Company	Trenz Electronic GmbH
PCN Number	PCN-20190112
Title	TEB0911-04-* SPI Flash and eMMC Change
Subject	BOM change
Issue Date	2019-09-09

This change affects all Trenz Electronic TEB0911-04 carrier: TEB0911-04-*

2.3 #3 Change R65 to 1K

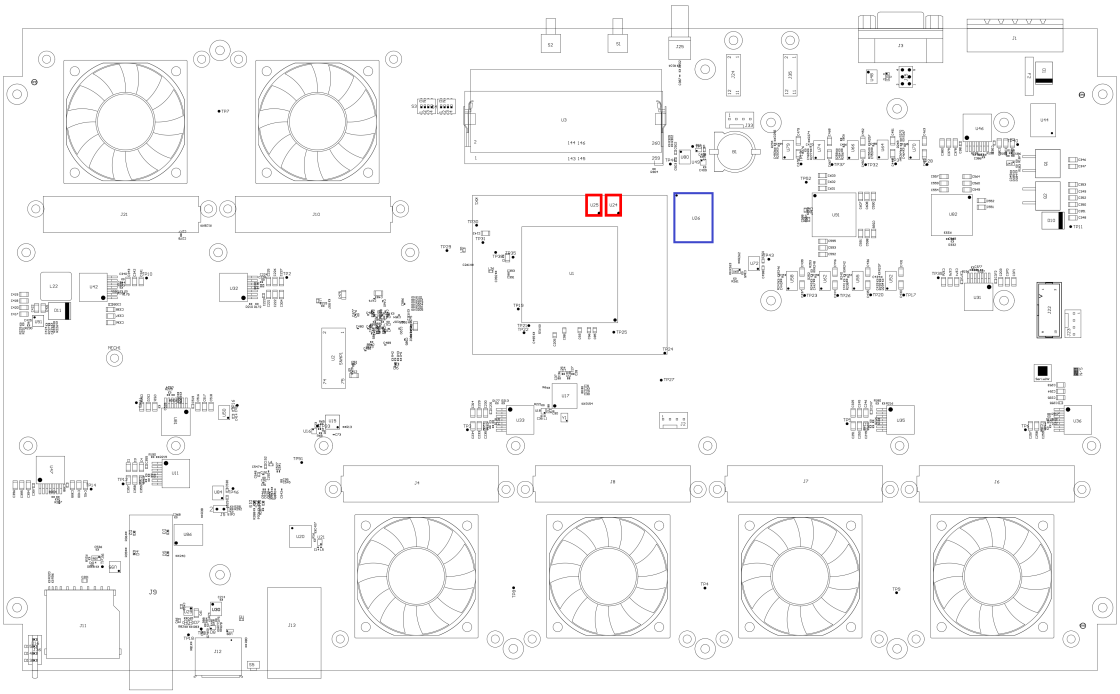
Reason: USB connection problem on some carriers reported

Impact: USB connection works reliable

Locate Flash (U24, U25) on top side of PCB and eMMC (U26):

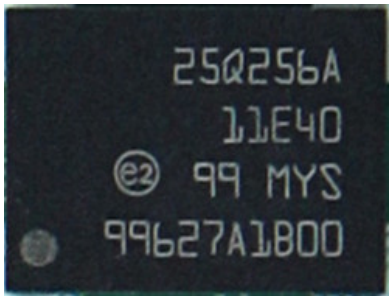
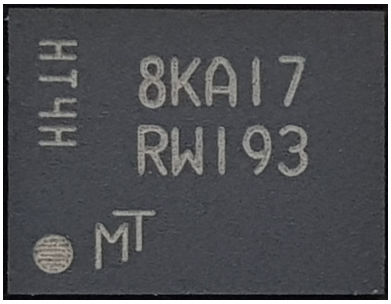
old	new
N25Q512A11G1240E	MT25QU512ABB8E12-0SIT

old	new
MTFC4GACAJCN-4M IT	IS21ES08G-JCLI
